Bid Bulletin #02

PROJECT: Gateway Early Childhood Center
Bid Package #4
Omaha, NE

ADDENDUM E

Gateway Early Childhood Center
Omaha, Nebraska
RDG Project No. 2014.129.00, File 35.1

BRICK BANDING LEGEND

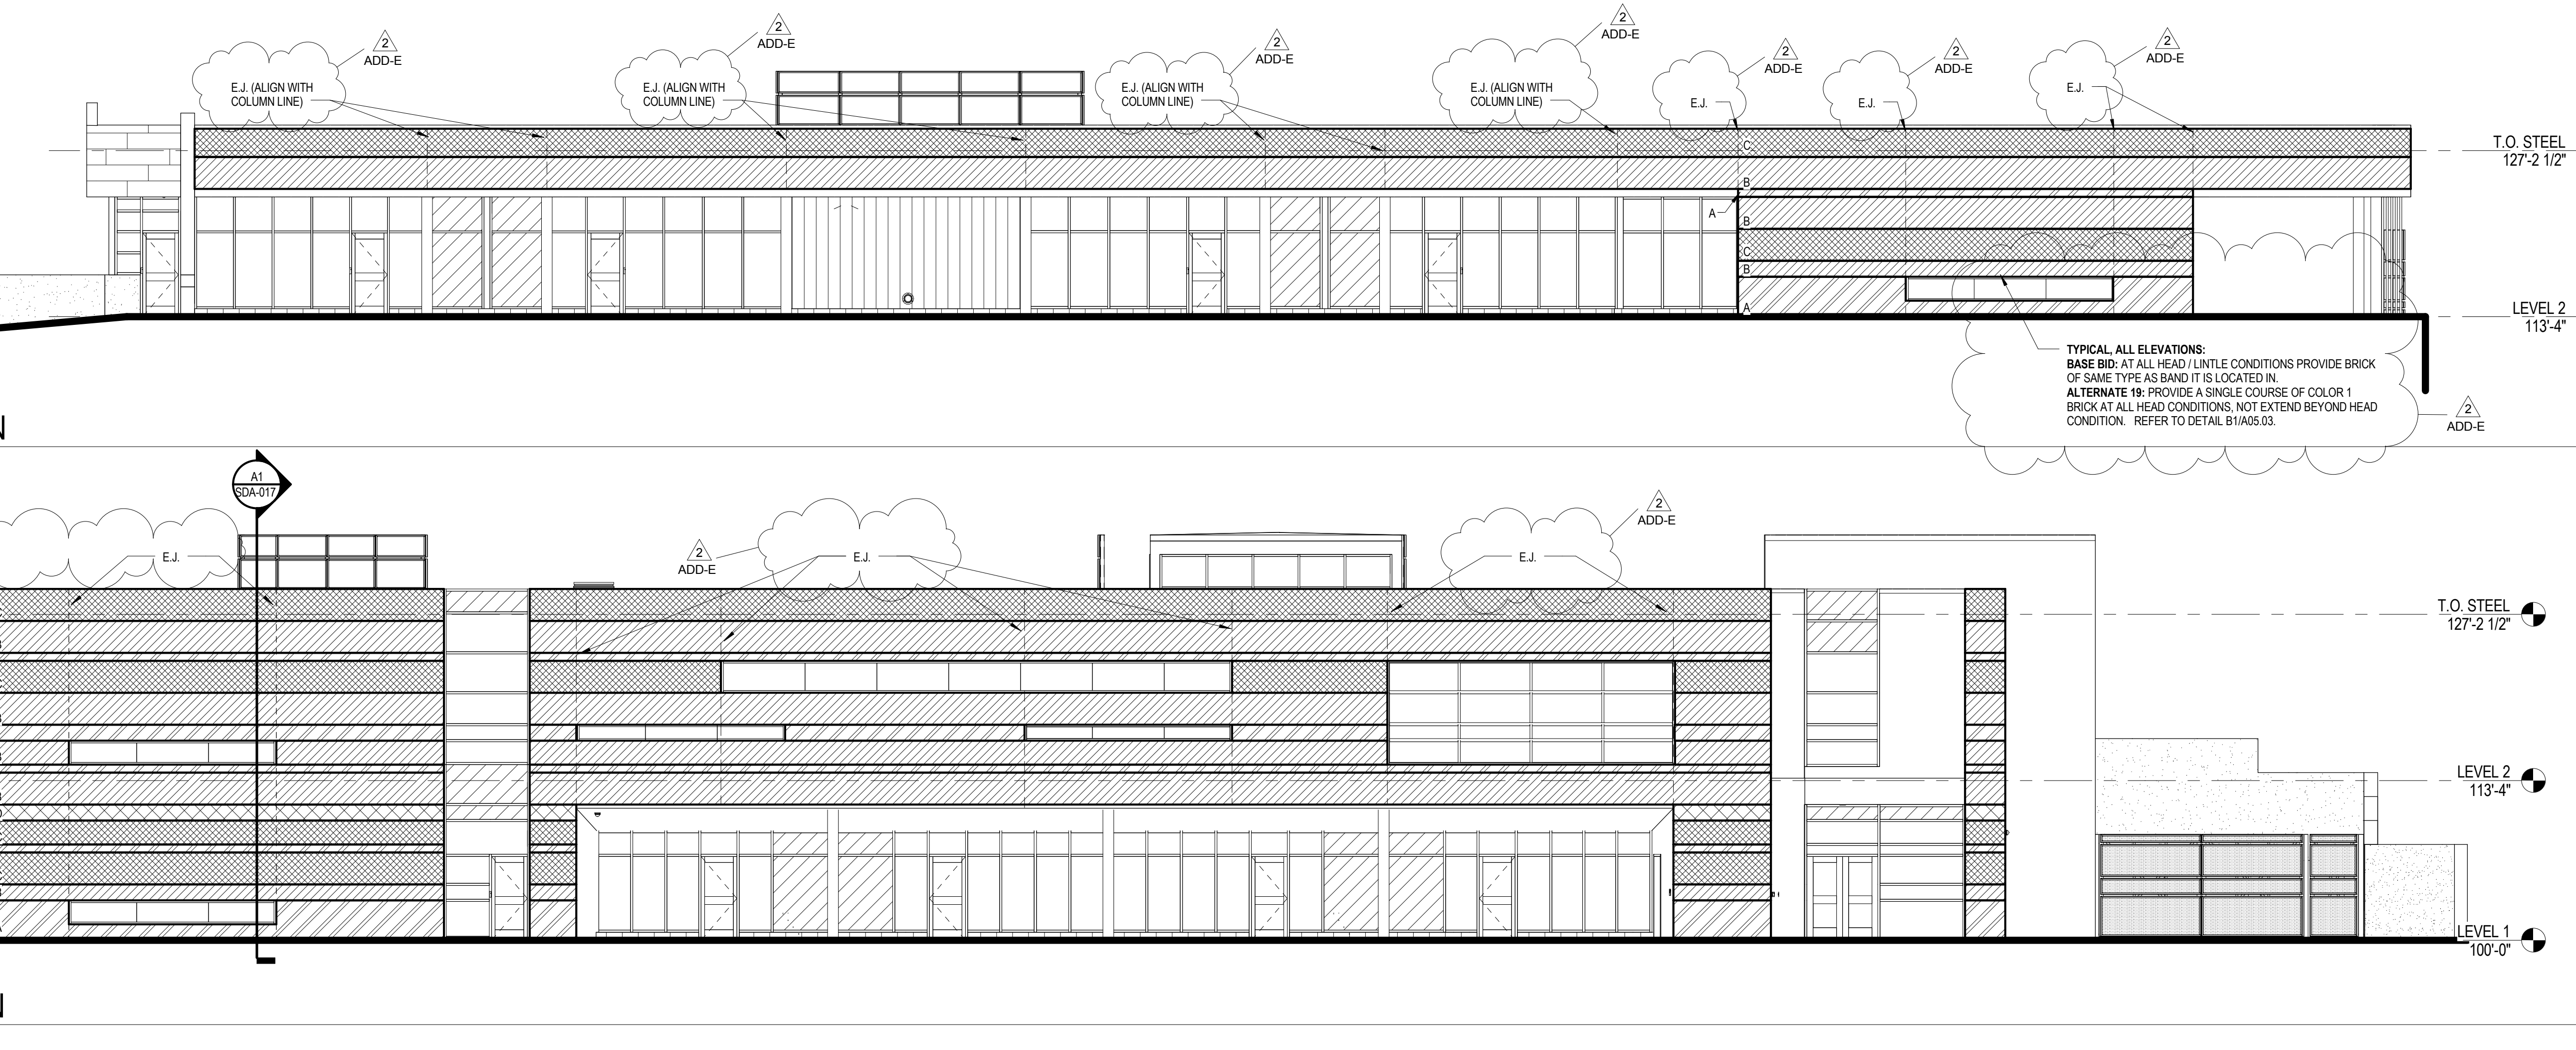
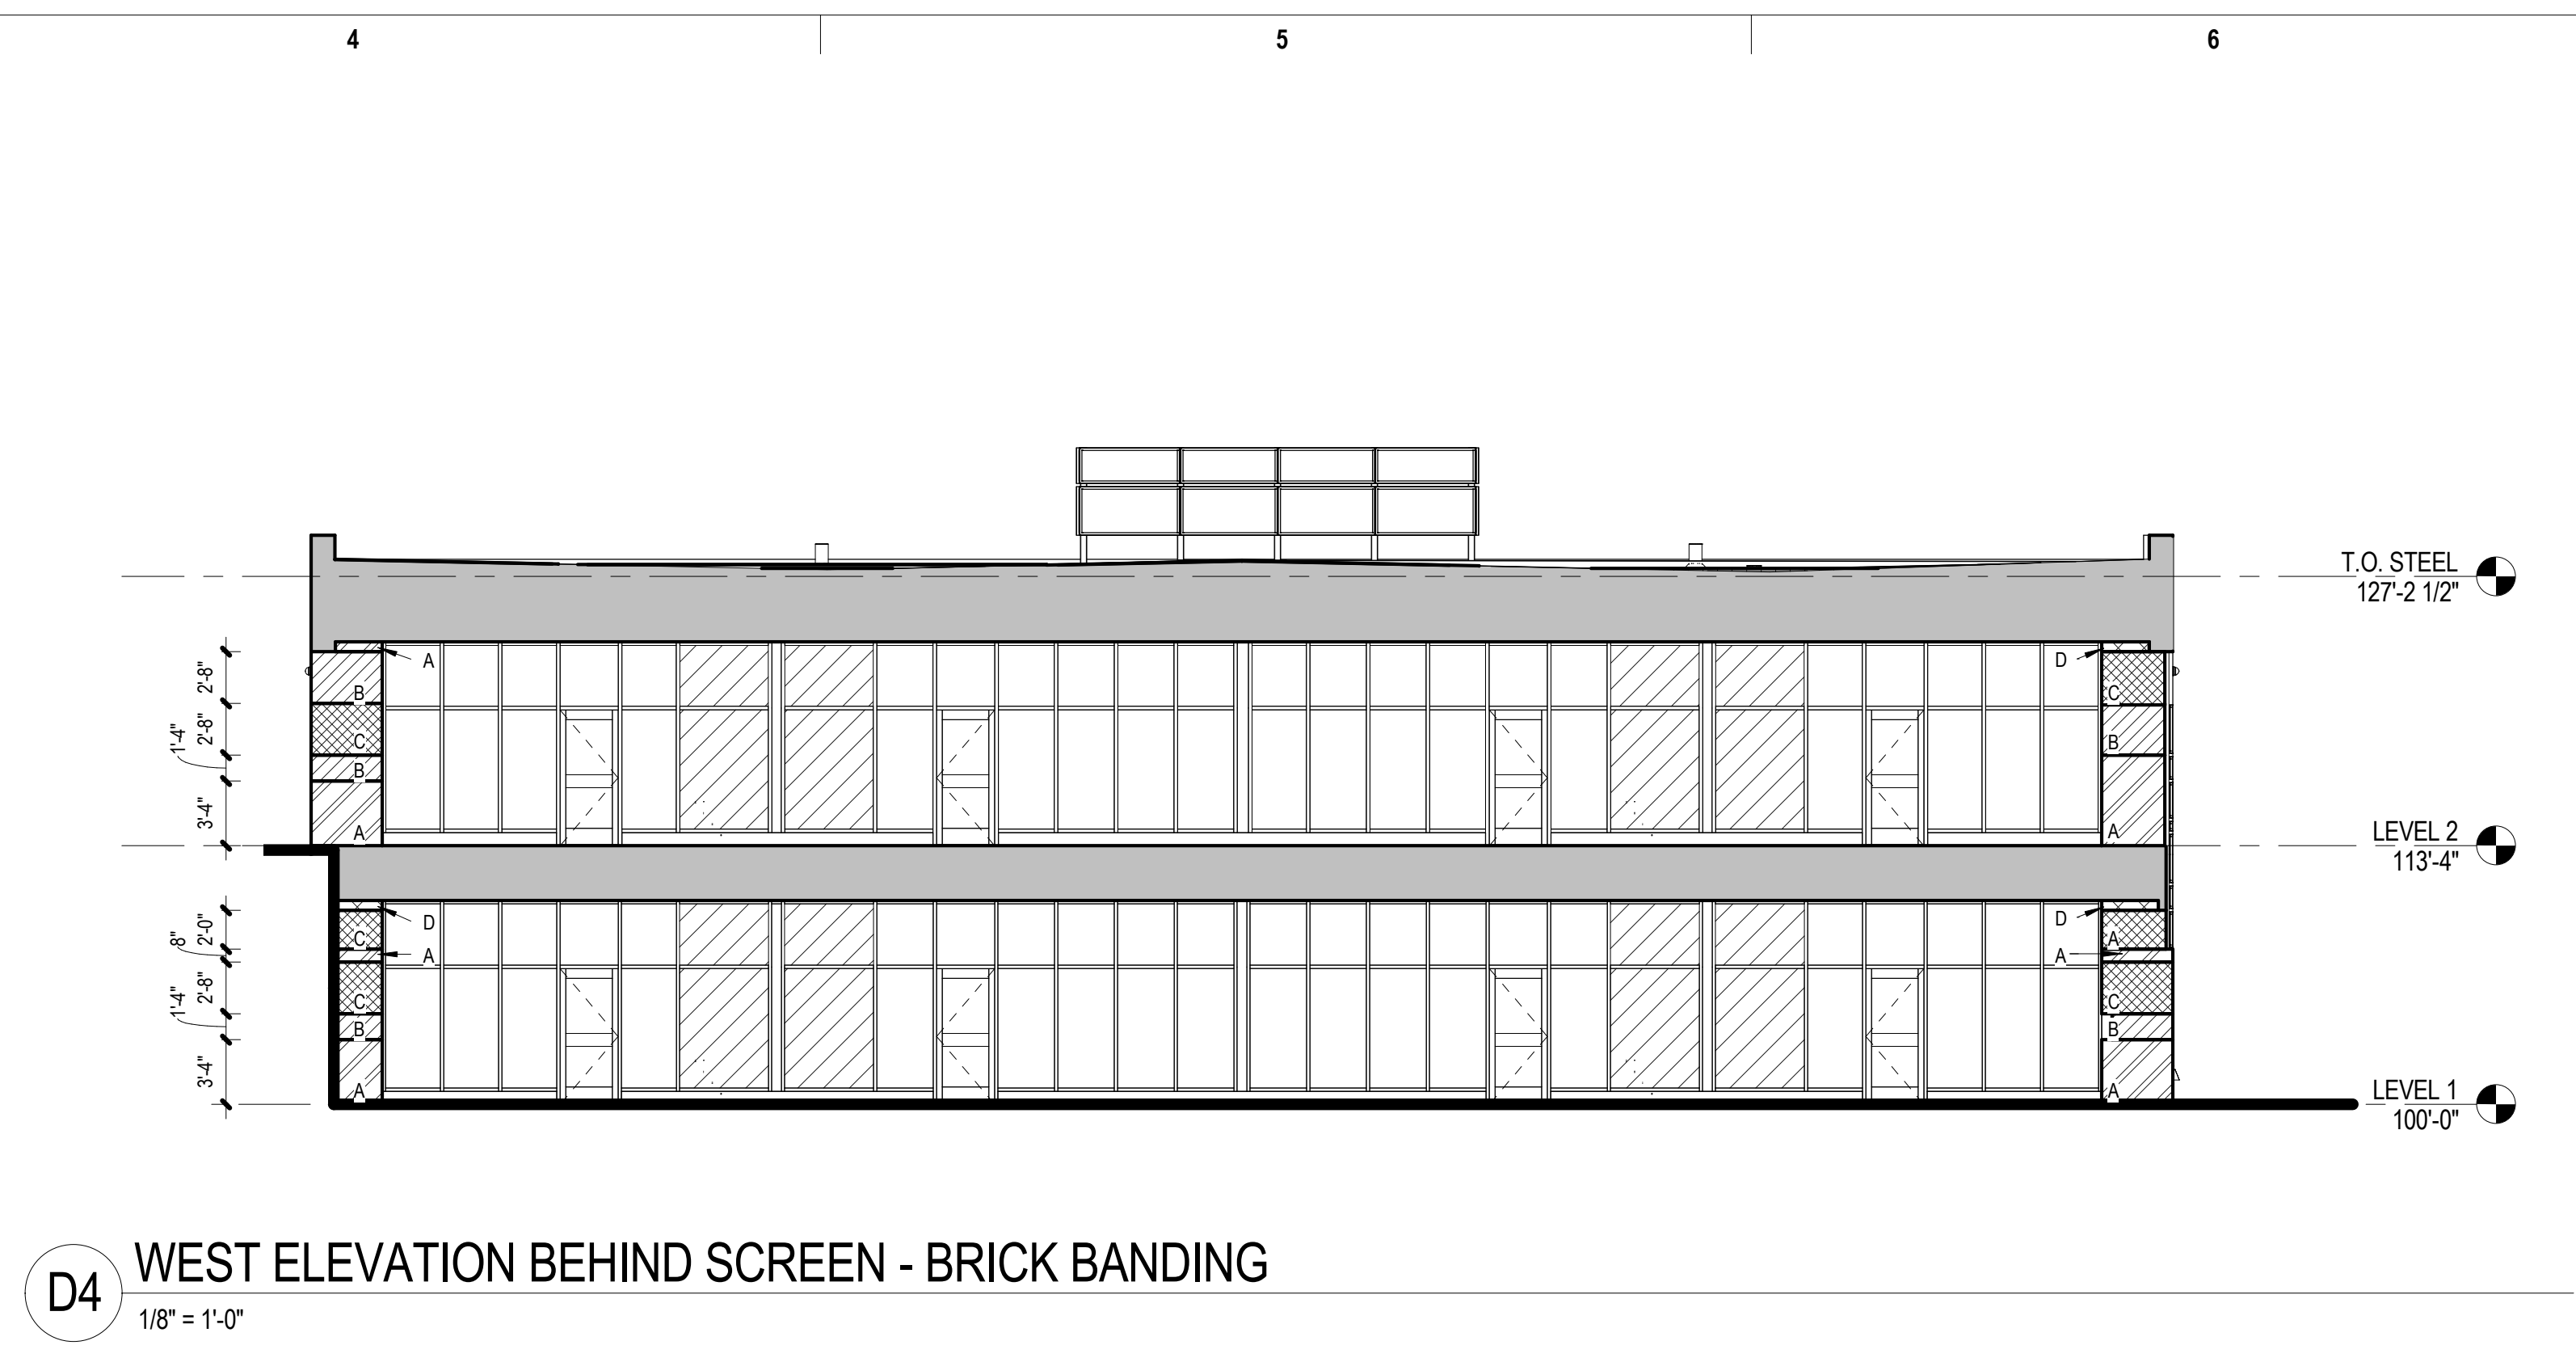
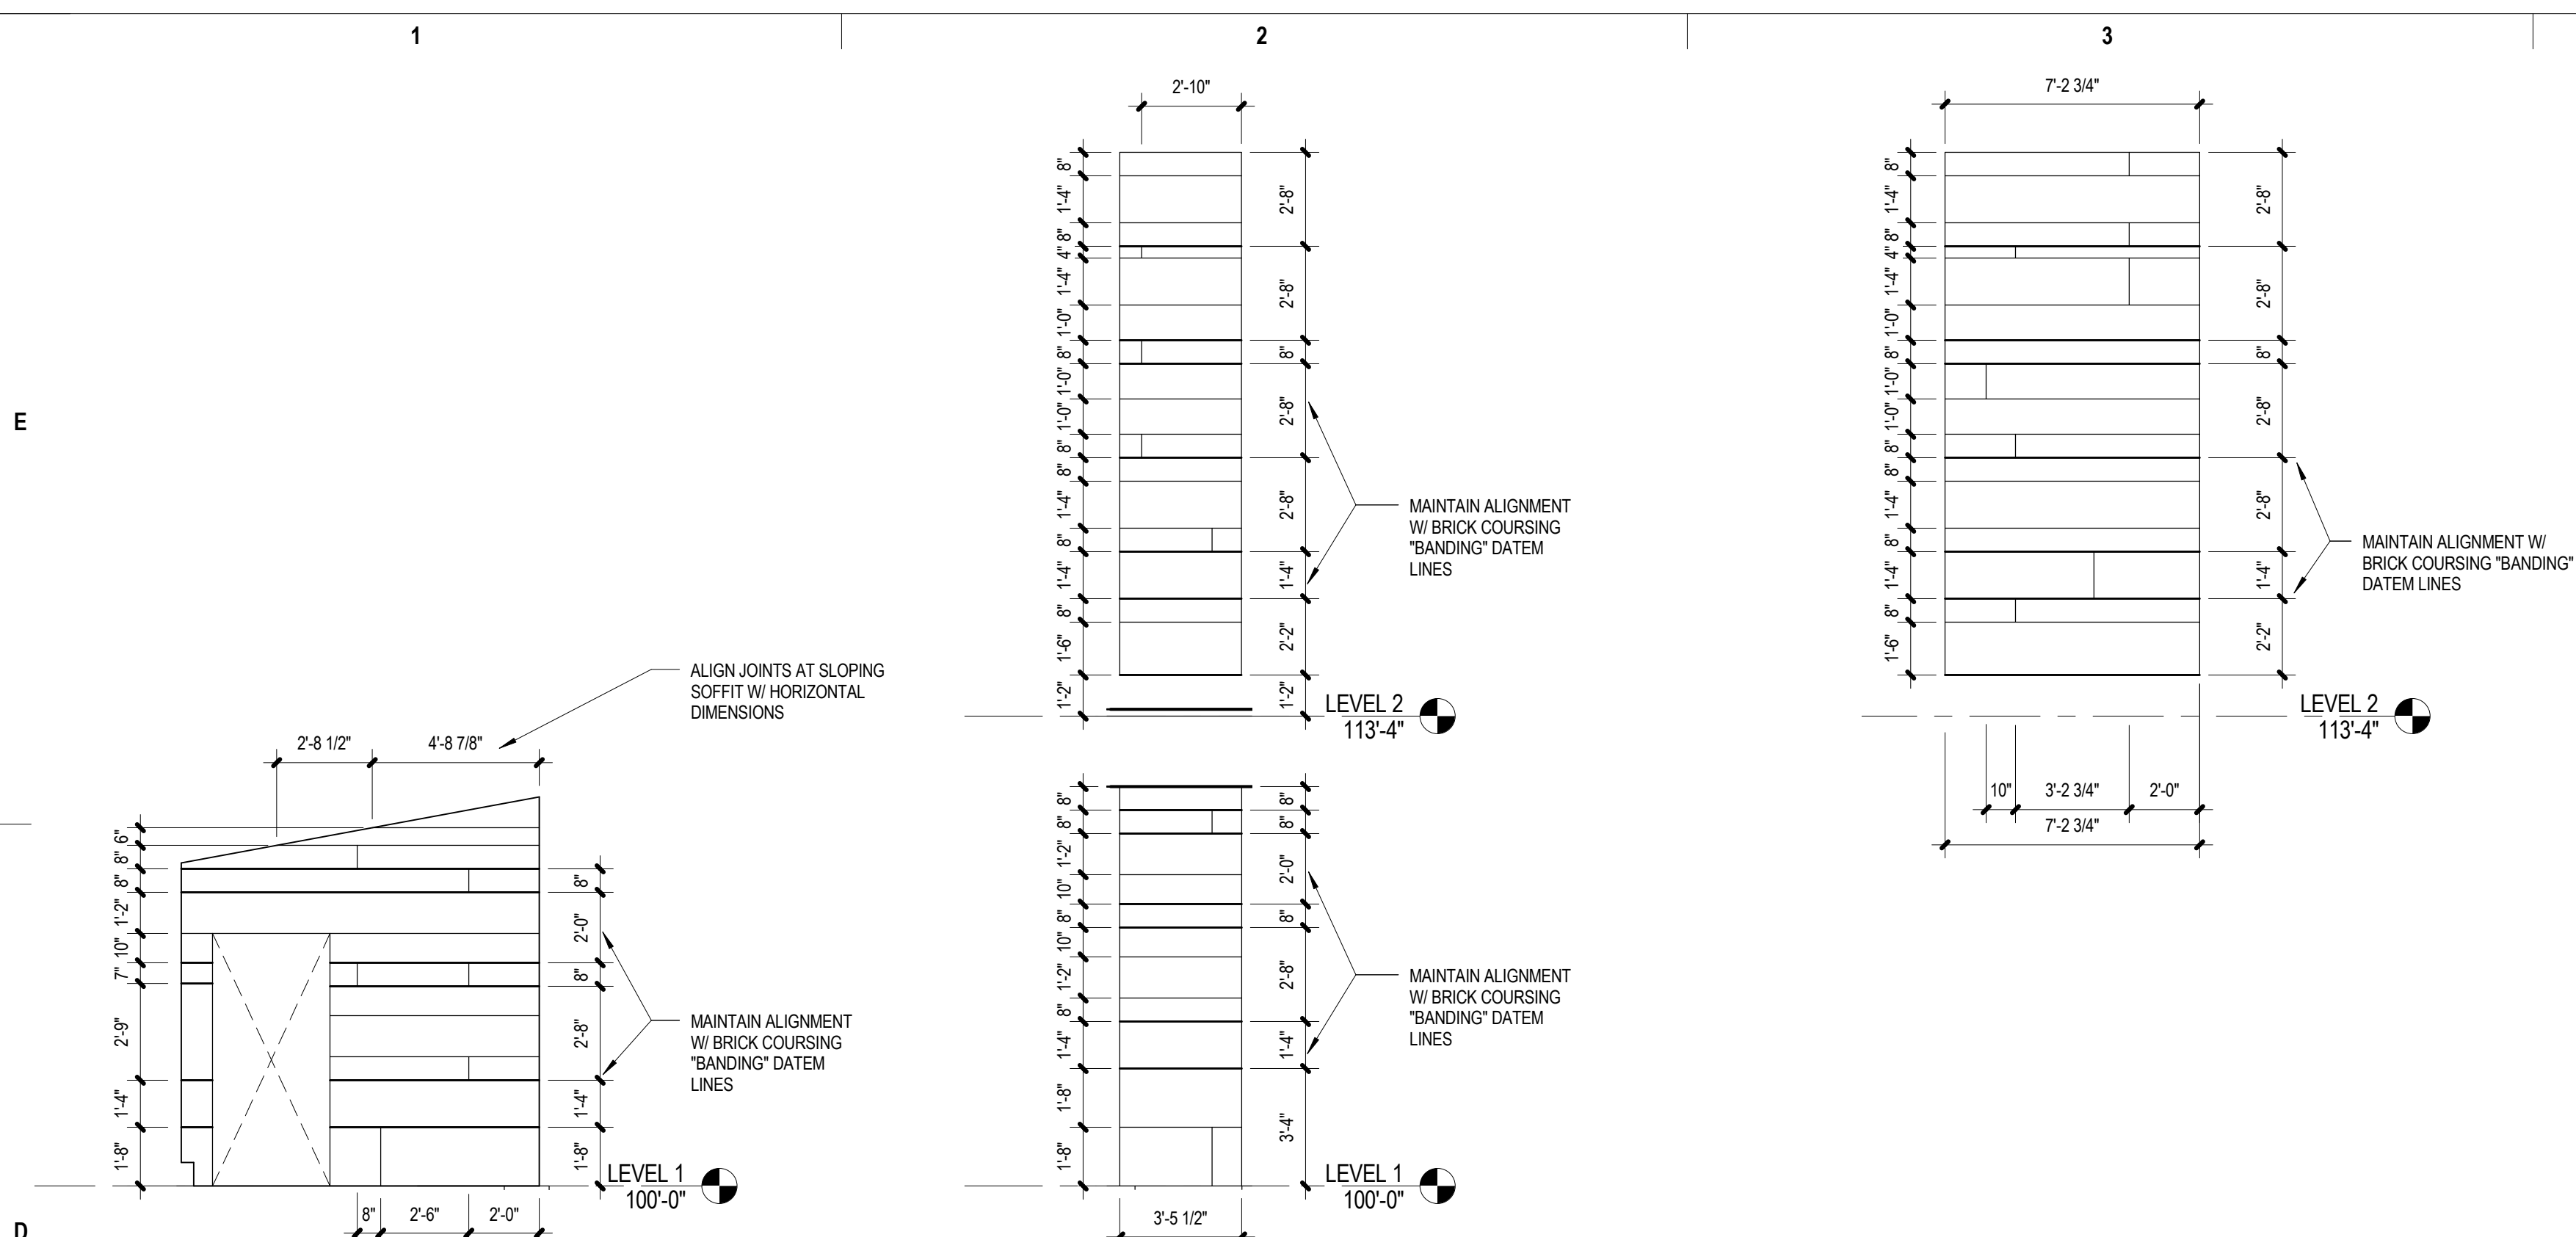
- A. A2 – “South Elevation:” Brick veneer expansion joints indicated.
- B. B1 – “Stepped Brick Rules:” Add “Brick Stepping Summary” as shown to clarify brick stepping. Modify note at window head as shown to clarify that the single course of Color 1 brick should not extend beyond window head conditions.
- C. B2 – “North Elevation:” Brick veneer expansion joints indicated. Add typical note indicating brick at head conditions for both Base Bid and Alternate 19.
- D. C4 – “East Elevation:” Brick veneer expansion joints indicated.
- E. Brick Banding Legend: Update type designations to clarify base bid brick stepping.
